Occupant and Cargo Carrying Capacity Label - Incorrect Length Information

Bulletin Type:	TSB	Publication Date:	January 2026
Bulletin #(s):	26-001	Make(s):	Jayco
Job Code(s):	9803645	Model(s):	Redhawk SE
Flat Rate(s):	9803645 - 0.3 Hr. Labor - Replace OCCC Label	Model Year(s):	2025 -2026

Occupant and Cargo Carrying Capacity Label

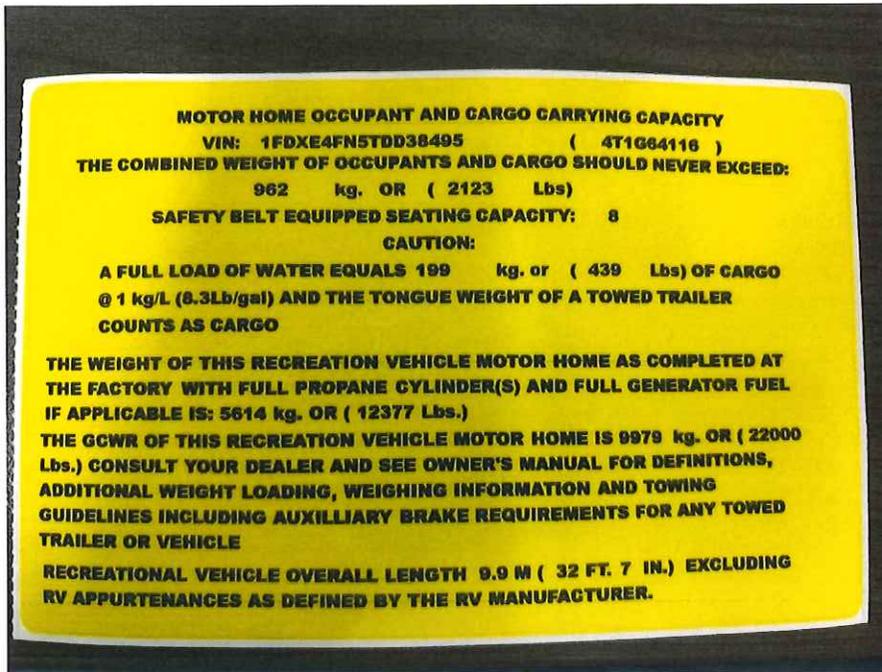
Incident:	Length information listed on the Occupant and Cargo Carrying Capacity (OCCC) label is incorrect.
Affected Units:	2025 – 2026 Jayco Redhawk SE
Part:	Part: The Occupant and Cargo Carrying Capacity Label is enclosed in Owner/Dealer notification letter
Misc. Tools & Supplies:	Isopropyl alcohol Shop rag
Parts Return Information:	N/A

The Occupant and Cargo Carrying Capacity label below is only an example of the label you are to replace.

1. The OCCC (Occupant Cargo Carrying Capacity) label for the Redhawk SE located on the driver side door jamb pillar and the other label will be affixed inside of the entry door.
2. Remove the existing labels. Using isopropyl alcohol and a shop rag, remove any adhesive residue from the surface where the original labels were removed.
 - a. Allow the area to dry for at least 30 seconds.

1. Remove the protective back from the new labels. Align the new labels in the same location of the original labels and apply it to the surface. Remove any air bubbles from the labels.
 - a. Note: Do not attempt to remove or adjust the labels once it has touched the surface. Doing so may damage the labels or cause them not to adhere properly to the surface.
